Addendum No. 1
Rock River Water Reclamation District
Plant Roadway Replacement 2019
Capital Project No. 2006

This Addendum Number 1, dated May 6, 2019, for the above referenced project, supersedes all contrary and conflicting information in the specifications and contract documents, which are hereby supplemented or revised as follows:

PLANT ROADWAY REPLACEMENT 2019

CAPITAL PROJECT #2006

| SITE PLAN | Sheet No. 6 OF 12 |

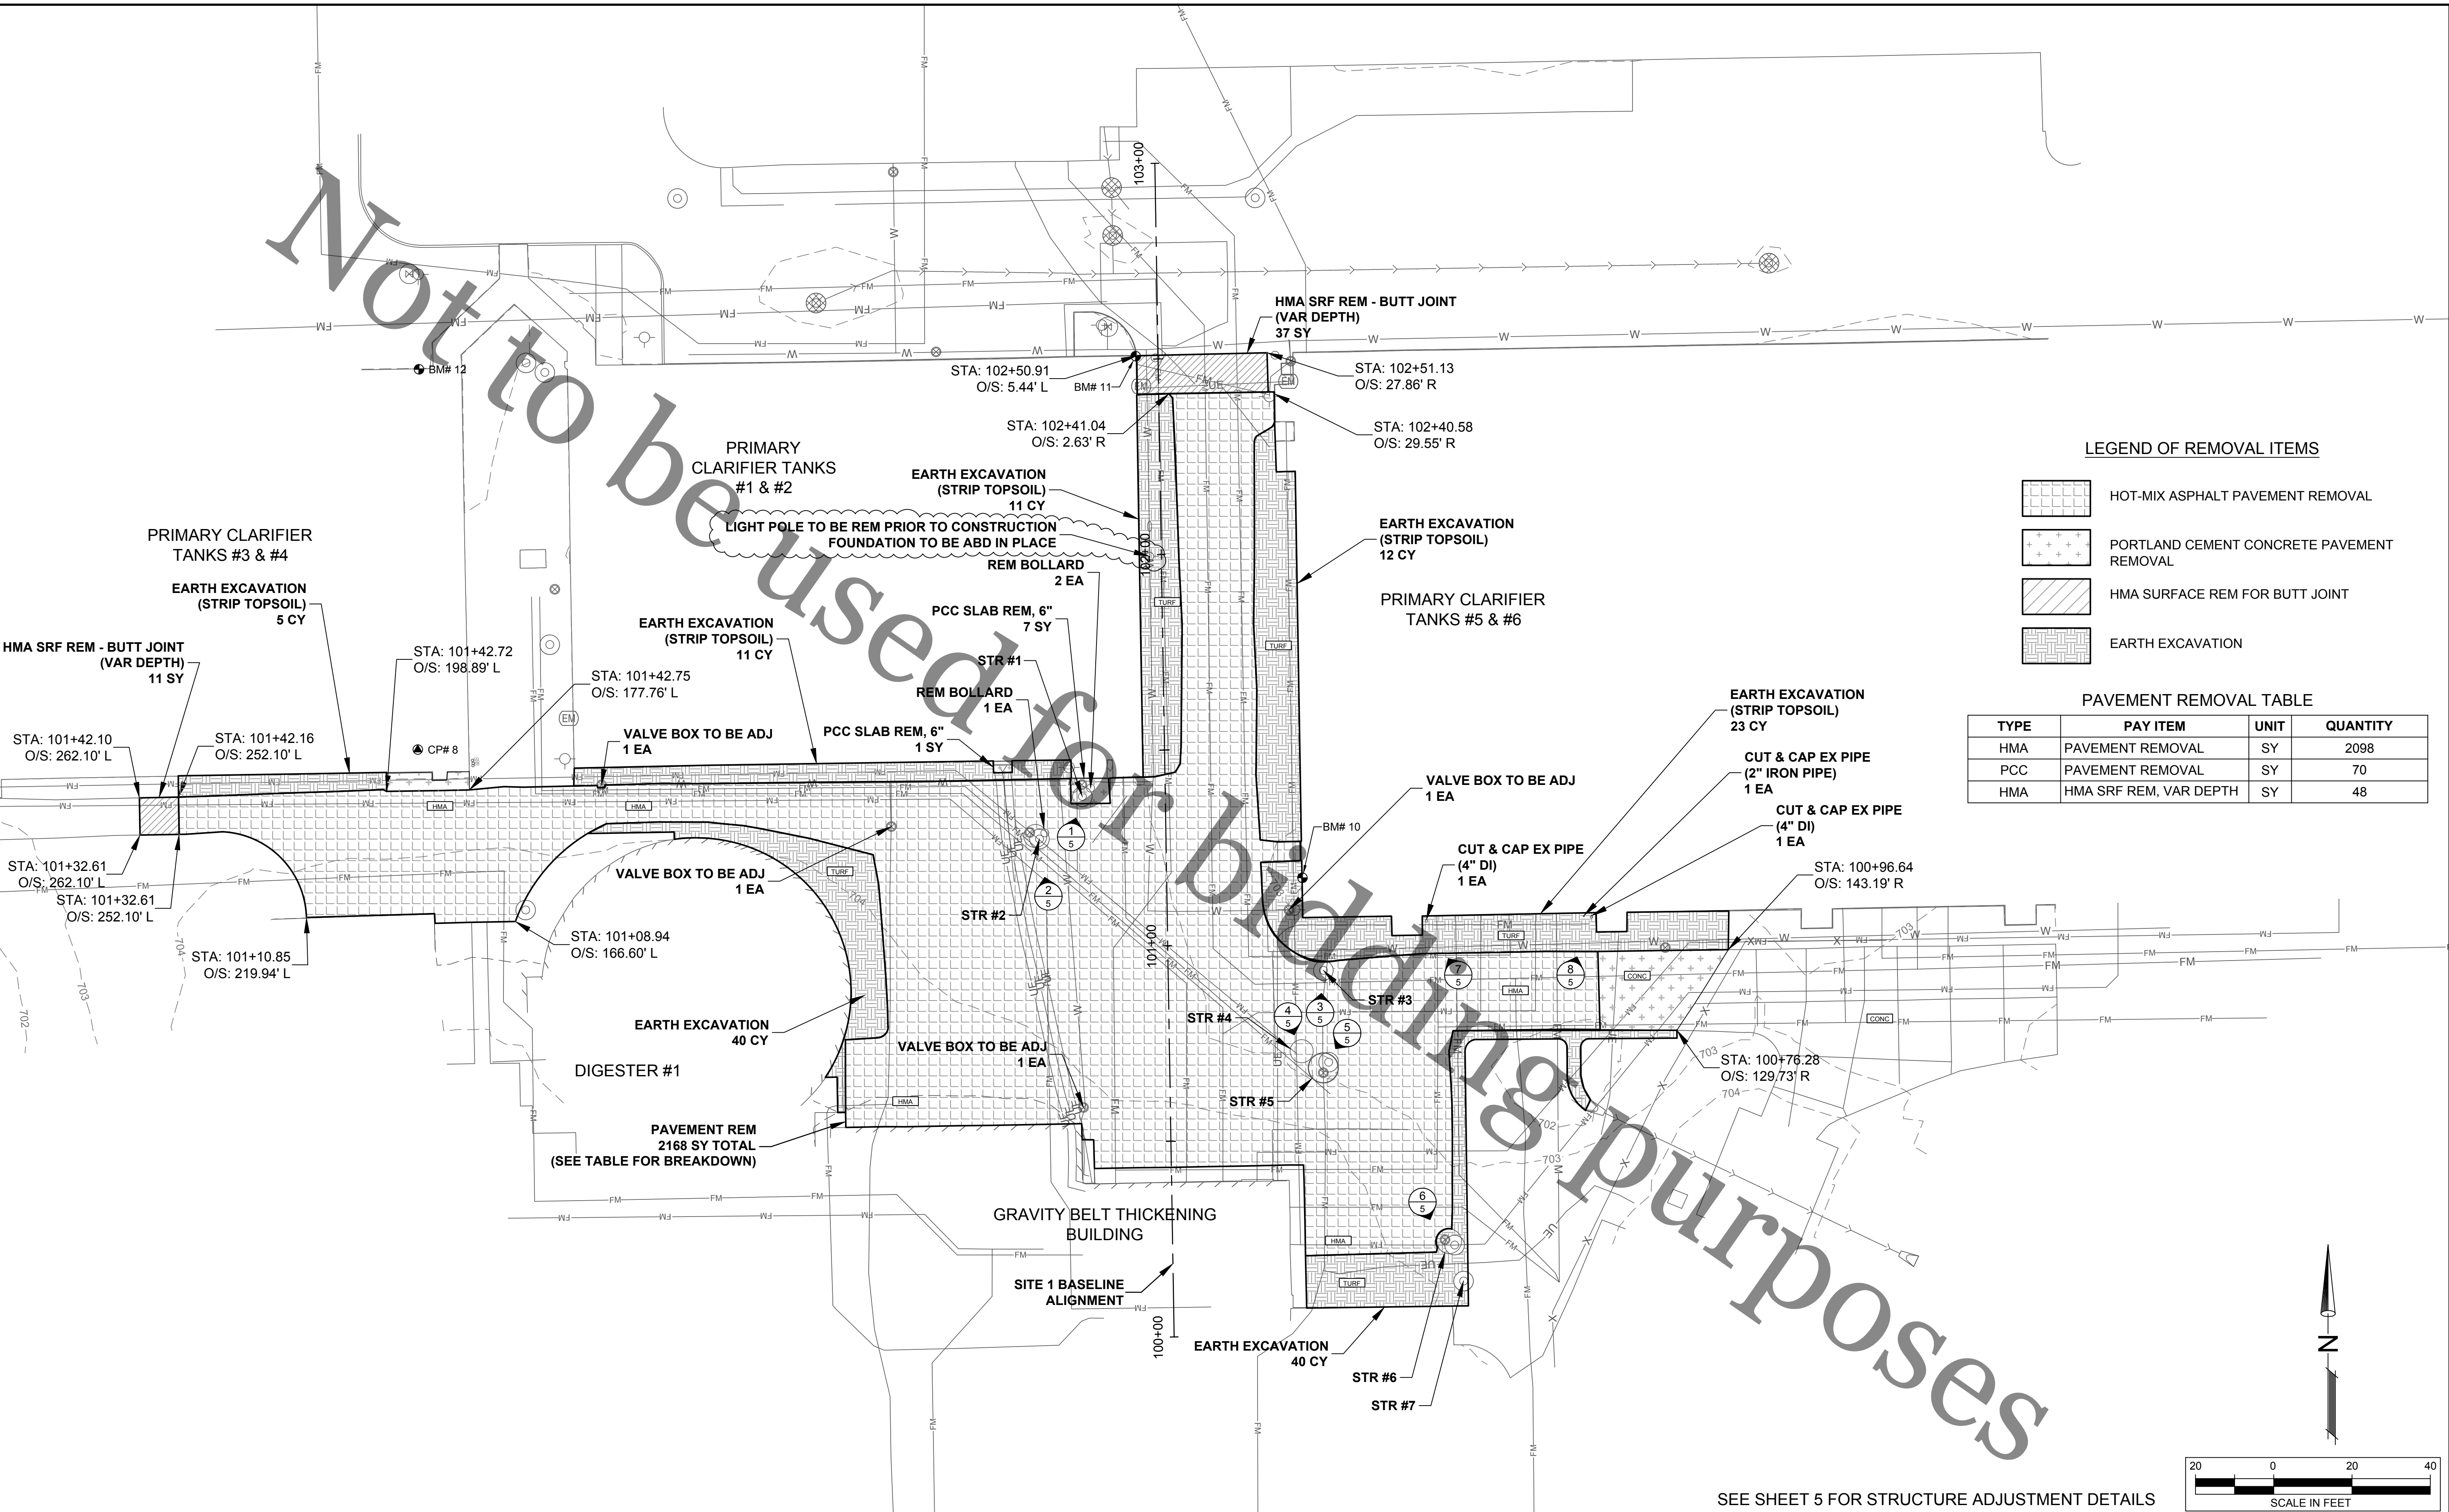
Sheet 6 of 12: SITE PLAN

1. Plan view has been updated to reflect the addition of the LIGHT POLE FOUNDATION, 1 EA pay item located at approximately STA 101+97, 5' LT (the exact location will be determined in the field).

| No. | DATE | REVISION | INT. |
|-----|--------|--|------|
| 1 | 5/6/19 | ADDED NOTE & SYMBOL "LIGHT POLE FOUNDATION, 1 EA. EXACT LOC TBD IN FIELD" @ 101+97 6' LT PER AD. #1. | KG |
